SUB: Permission for uploading software version 30 (1E) in CGPISL make IGBT Traction Converter

Sub: Issues in CGL IGBT Traction Converters – Reg

Sub: Performance of CGL IGBT software Version 30 Beta 04 -reg

8D Report

Figure 1: DC-link voltage at the time of OCR action

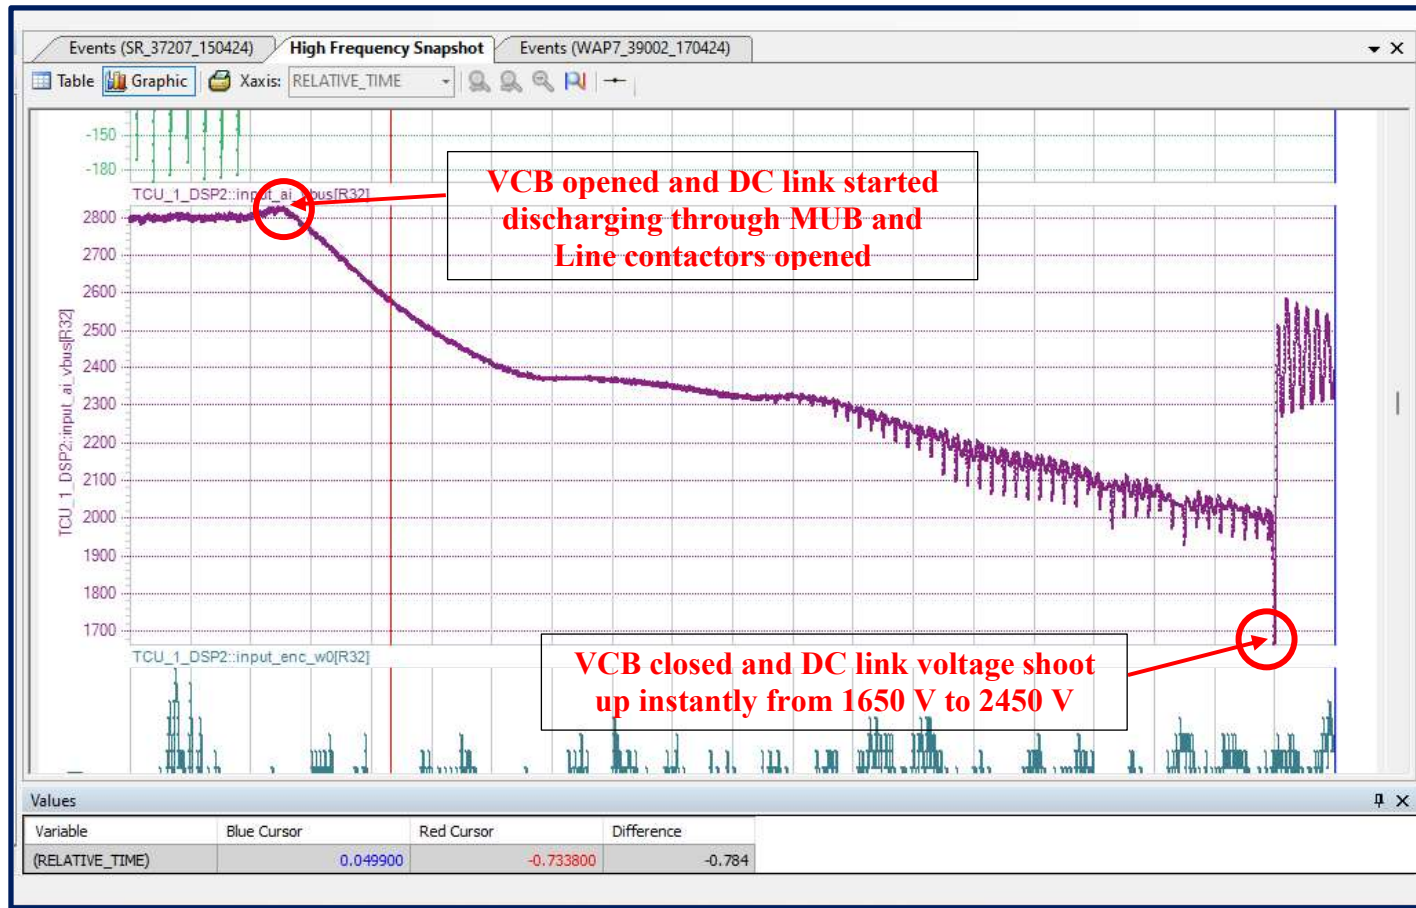
3. This is because in **CGL Traction Converter's (SR's)**, when every time VCB opens, **Line contactors get opened and DC link discharged through MUB resistor (Figure 1)**. When VCB is closed again, for immediate charging of DC link capacitor (since DC link voltage is too low) rectifier draws over current instantaneously (above 2400 A) and causing heavy inrush primary current (above 960 A). This has caused OCR action in the above failed locomotive.

From the above graphs it is inferred that DC link voltage is discharging after opening the VCB and pulsing of the rectifier H-bridge immediately after closing of the VCB in such a manner that drawing of inrush current by DC link capacitors (DC link voltage set value 2450 V – actual DC voltage at the instant of VCB closed 1650 V(Figure 1)). This sudden increase in the DC link voltage causes over current to flow in the rectifiers of both the Traction converters and hence the primary circuit. In MICAS and other propulsion DC link voltage is maintained and Line contactors remain in closed condition during VCB opening and DC link voltage will be discharged only at the time of protective shutdown.

Hence it is advised to analyse the above issue in the CGL IGBT SR and come up with suitable changes in the CGL SR software.

Figure 2: Input Current at the time of OCR action

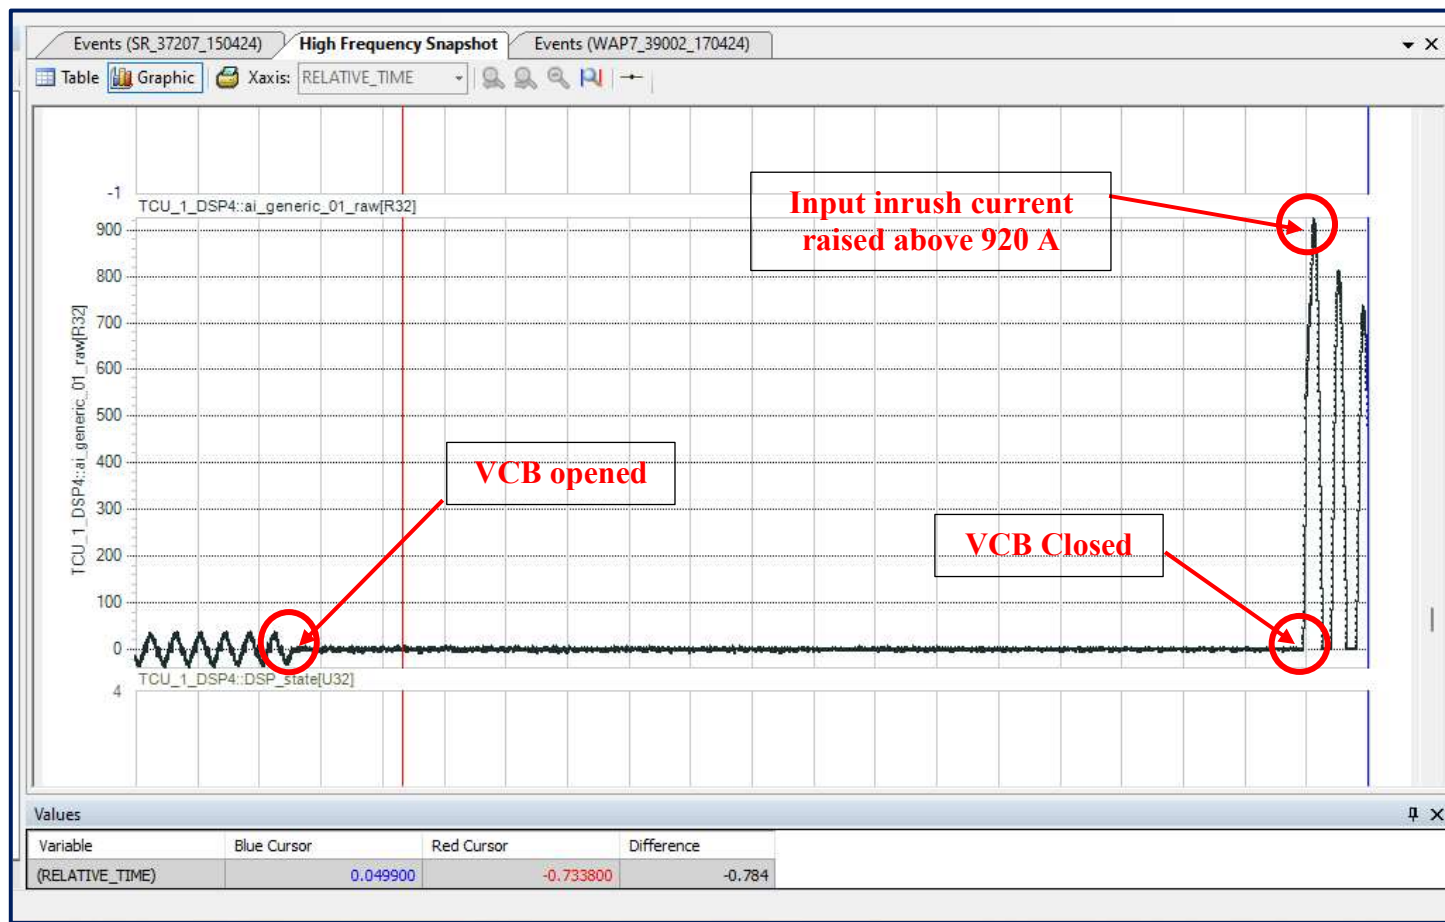
2. It is noticed that Rectifier Line 1 & 2 over current logged from both the SR's for several times during VCB reclosing time. As per SR data at the time of OCR action, input inrush current has gone beyond 960 A (Figure 2) and rectifier over current also logged (Figure 3).

Figure 1. Over Current LF SNS background.

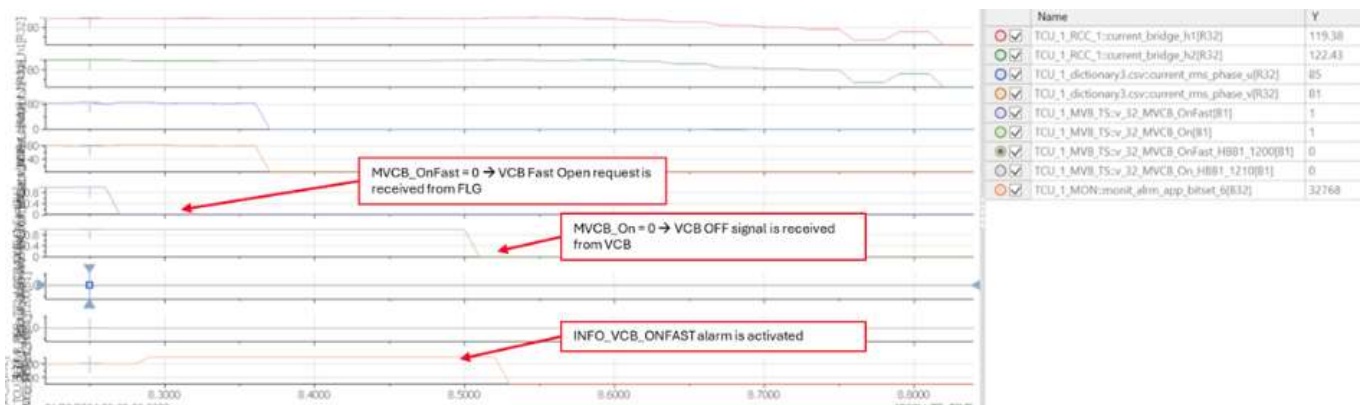
1. The SLG received from the FLG the MVCB_OnFast = 0 signal so a FastOpen request is sent to the SLG from the FLG.
2. After a few ms, the SLG received the confirmation from the FLG that the VCB was open (MVCB_On=0).
3. Despite of receiving the OnFast request and the confirmation from the FLG that the VCB was open.

4. When the FLG sent to the SLG a FastOpen request the SLG prepared itself to open the VCB and started stopping all the converters starting from the inverter.
5. After 1 second from the OnFast request, a catenary/rectifier input phase overcurrent situation happened. In that moment, the SLG (TCU) detects the over-current situation and protects as expected.

- In a noticed neutral zone, the switching management of the rectifier IGBT-s has been modified, stopping them as soon as the neutral zone signal is received.
- The SLG main contactor will remain closed until the DC-Link voltage drops below 1700V. In case of leaving the neutral zone before the voltage drops below 1700V, the SLG will be recovered by starting to switch with the main contactor still closed.
- If due to the neutral zone the DC-Link voltage drops below 1700V, the SLG will open contactors, completely discharging the DC-Link and requiring the normal bus charging sequence to be done.

Figure 2. Over Current HF SNS background.

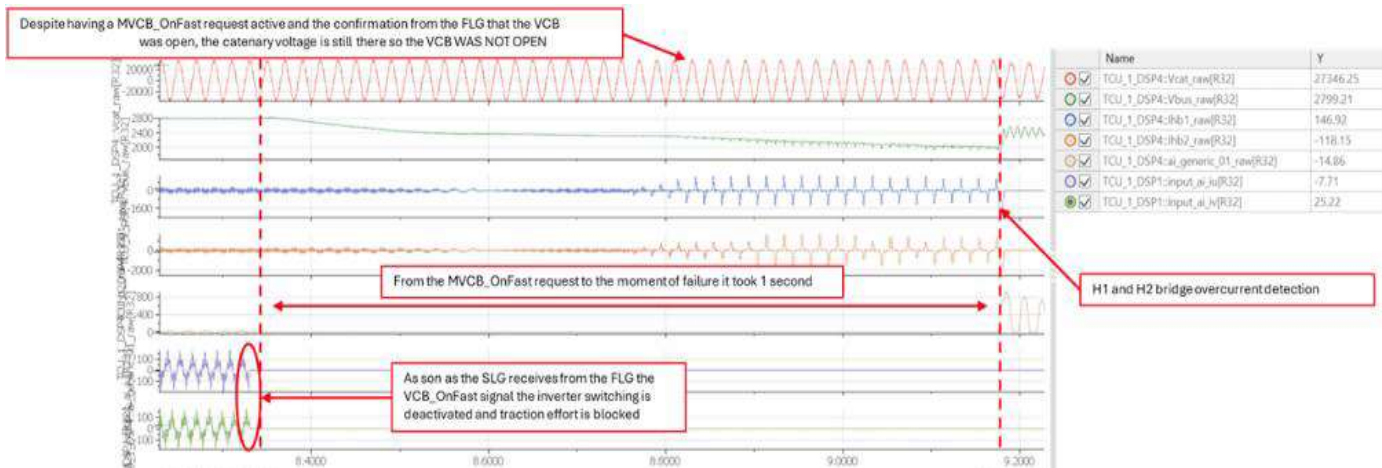
From the data obtained from the high frequency SNS of the SLG, it is observed that the catenary or OHL voltage does not drop at any time as it should in a neutral zone noticed by the driver. For this reason, the RCU IGBT-s are kept switching after VCB opening. Otherwise, the motor currents are switched off as soon as the opening signal is received from the driver.

The SLG contactors are kept closed, maintaining the DC-Link voltage which is still discharging by the permanent discharge resistors (safety protection).

1s after the neutral zone notice and the VCB closure, with no OHL loss, as the rectifier IGBT-s are still switching, the unexpected current peak and instantaneous loss of both SLG-s occurs, which are then able to recover and become operational again after a few seconds.
